Federal Recall Information

13KWJ

Kenworth Truck Company

Recall 13KWJ - ISL Alternator Wiring

Figure 1 – Positive cable goes **DOWNWARD, OK**, no further action required

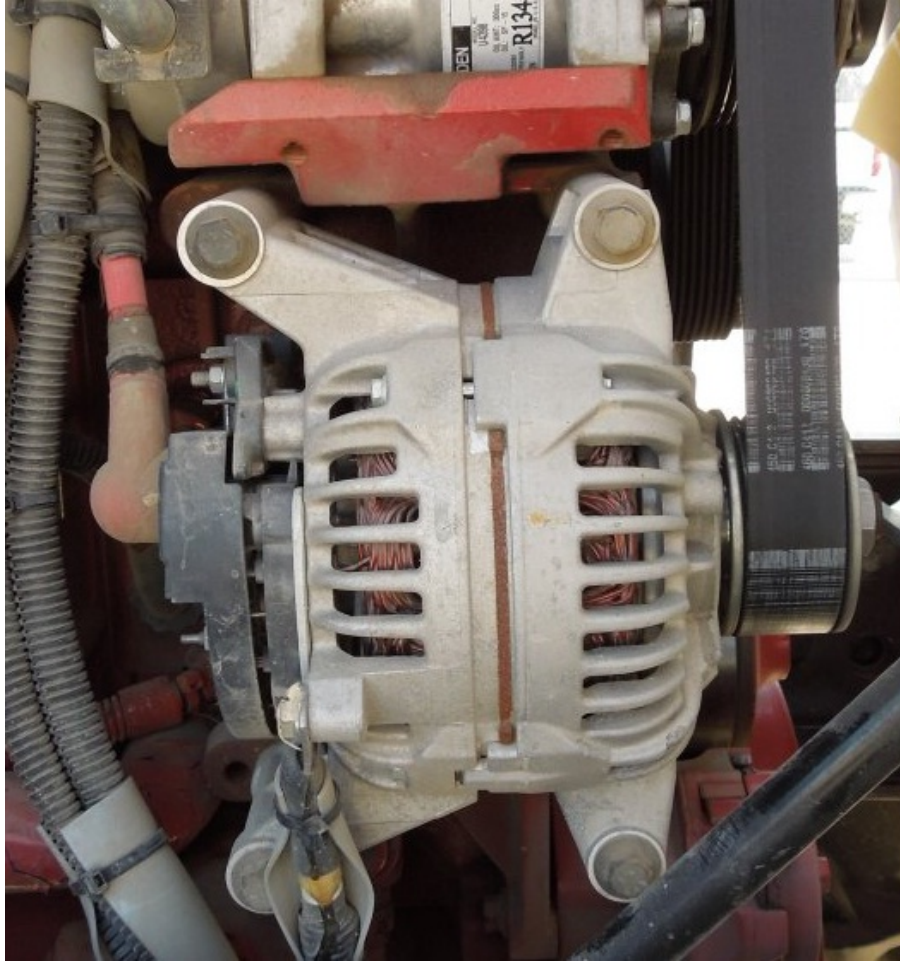
Inspect the routing of the alternator charging harness. If it is routed from the alternator in a **downward** direction (see Figure 1 below), **no further action is required**. File Quick Claim 13KWJ1, which will pay 0.3 hr labor to inspect.
